**PLANNED UNIT DEVELOPMENT &
PLANNING APPROVAL STAFF REPORT****Date: August 7, 2008****NAME**

Springhill Presbyterian Church

Planning Approval to allow the expansion of an existing church in an R-1, Single- Family Residential District, to include a new chapel building, and Planned Unit Development Approval to allow multiple buildings on a single building site.

SITE PLAN

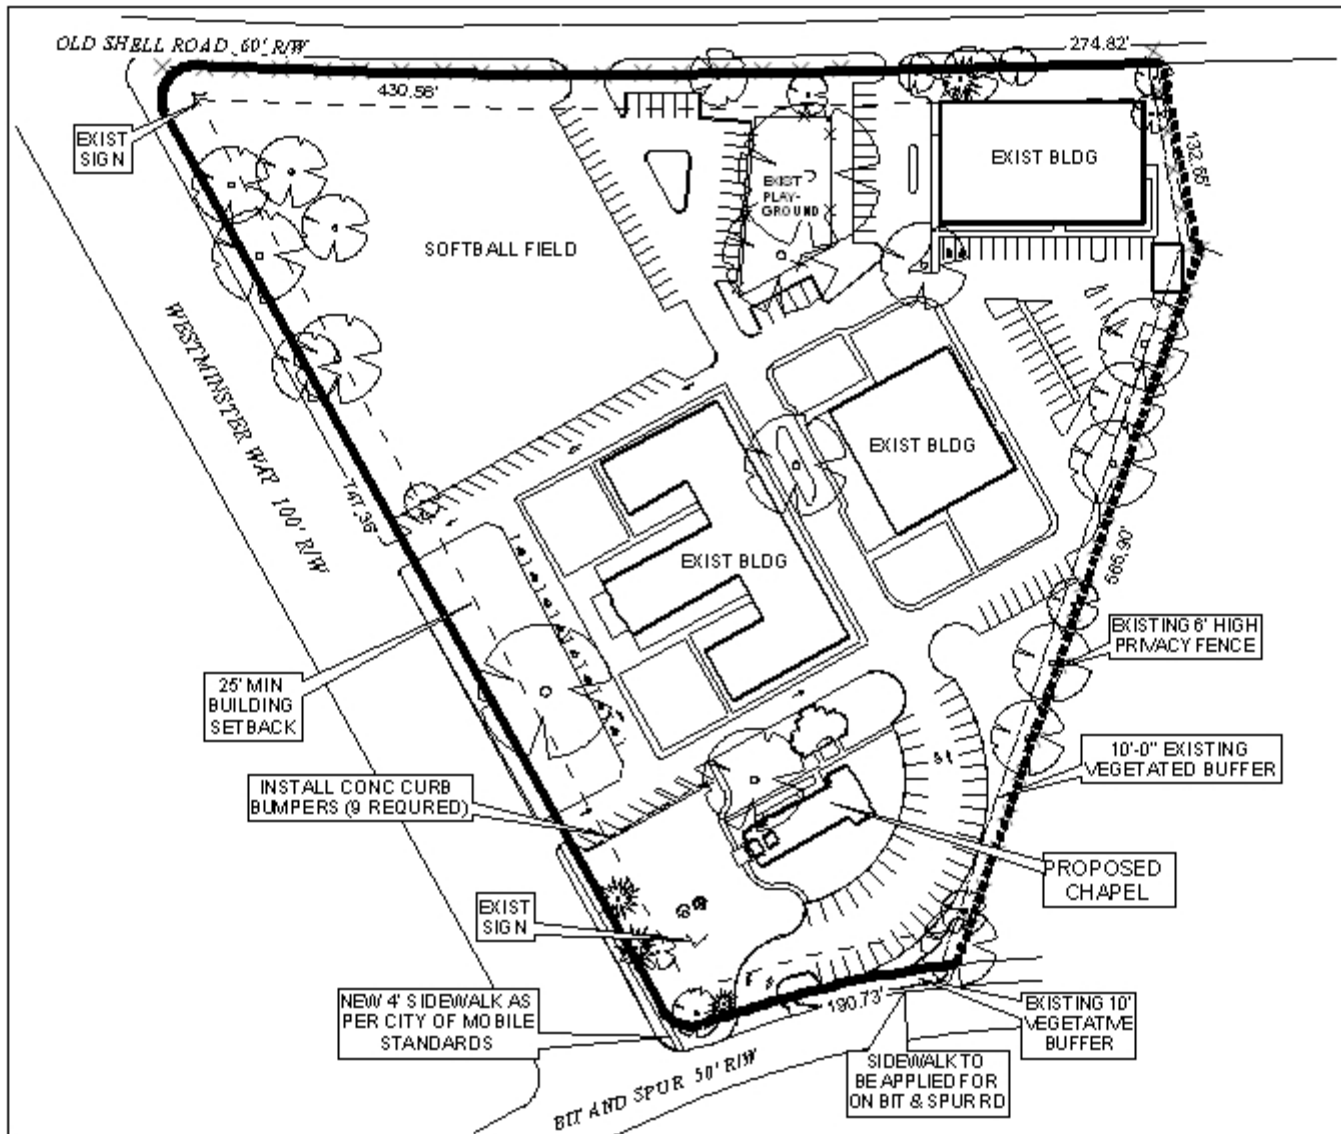
The chapel will be located between two existing parking areas, and the site plan indicates that an existing 64-inch “water oak” will be removed. Staff has verified that the tree is in fact a specimen-quality red oak. The site plan should be revised to correctly identify all existing trees and their sizes. Adequate room exists on the project site to move the proposed chapel approximately 7 feet to accommodate the existing red oak, and Urban Forestry has recommended preservation status for the red oak tree.

The site plan also lists information regarding compliance with the tree and landscaping requirements of the Zoning Ordinance, yet the site plan does not depict actual compliance with the tree requirements: no new trees are depicted. Staff recommends that the site be brought into full compliance with the frontage tree requirements for the entire site: Old Shell Road, Westminster Way and Bit and Spur Road frontages.

It should also be pointed out that new sidewalks proposed to serve the new chapel do not effectively serve the immediately adjacent parking areas. The sidewalks should parallel the abutting parking areas and provide direct access for these parking areas, so that church members or others using the chapel will not have to walk on designated landscape areas or between vehicles to reach sidewalks. The site plan should be revised to show improved pedestrian circulation.

No dumpster or other similar facility is depicted on the site plan. A note should be placed on the site plan stating that no dumpster will be used, or a dumpster facility should be depicted and labeled.

The site abuts a residential development to the East. The site plan should be revised to depict and provide a 10-foot wide buffer and a 6-foot high privacy fence (if there is no existing fence) along that portion of the boundary from Bit and Spur Road to the parking area where it meets the Eastern boundary.

- 1) Revision of the site plan to move the proposed chapel approximately 7 feet further way from the existing 64-inch red oak tree so that the tree can be retained;

- 3) Revision of the site plan to correctly number the quantity of parking spaces in each parking area;
- 4) Correct identification of all existing trees depicted on the site plan and their size;

- 5) Revision of the site plan to depict full compliance with the frontage tree requirements of the Zoning Ordinance for the entire site;
- 6) Revision of the site plan to show sidewalks along Bit and Spur Road, and along that portion of Westminster Way from Bit and Spur north to the first entrance into the church parking area;

- 7) Revision of the site plan to show sidewalks adjacent to all parking areas abutting the chapel and leading to parking access roads;
- 8) Depiction of curbing and/or bumper stops for all parking areas abutting the chapel site in order to protect adjacent landscape and sidewalk areas;

- 9) Revision of the site plan to depict the one-way circulation drives, to include the marking of the drives with arrows and/or signage to ensure correct circulation;

- 10) Revision of the site plan to depict and label a 10-foot wide buffer along the entire Eastern boundary, and a vegetative buffer or a 6-foot high privacy fence from Bit and Spur Road along the Eastern boundary of the site to the parking area where it meets the Eastern boundary; and

The applicant states that their intention is to keep the existing 64-inch red oak tree, and it appears that the proposed chapel will be approximately 28-feet from the trunk. Tree protection barriers at least 10-feet from the trunk of the tree, as well as any other tree that will be retained, should be depicted on any plans submitted for building permits, and should be in place prior to any land disturbance activities. Preservation status should be granted for any tree with a 50-inch or greater diameter breast height on the site.

Two new frontage trees are proposed along Bit and Spur Road, and two are proposed along Westminster Way. No additional frontage trees should be required other than as proposed due to existing trees either within the frontage area, or with large canopies that would interfere with the growth of new trees planted in the frontage areas.

The applicant will apply for a sidewalk waiver along Bit and Spur Road, but will provide a sidewalk along Westminster Way, adjacent to the project area. The sidewalk waiver application should be submitted prior to application for land disturbance or building permits.

The parking area was revised to provide bumper stops for those spaces lacking curbing, and to indicate directional arrows for circulation.

- 2) *Preservation status granted to any tree with a DBH of 50-inches or larger ;*
- 3) *Compliance with Urban Forestry comments (Property to be developed in compliance with state and local laws that pertain to tree preservation and protection on both city and private properties (State Act 61-929 and City Code Chapters 57 and 64). Removal of any live oak tree 24-inches or larger in diameter will require review and approval by Urban Forestry.)*

- 4) *Provision of two new frontage trees each along Bit and Spur Road and Westminster Way, as depicted;*
- 5) *Submission of an application for a sidewalk waiver prior to submittal for land disturbance or building permits; and*

- 6) *Provision of tree protection barriers at least 10-feet from the trunk of the tree, as well as any other tree that will be retained (depicted on any plans submitted for land disturbance or building permits), to be in place prior to any land disturbance activities.*
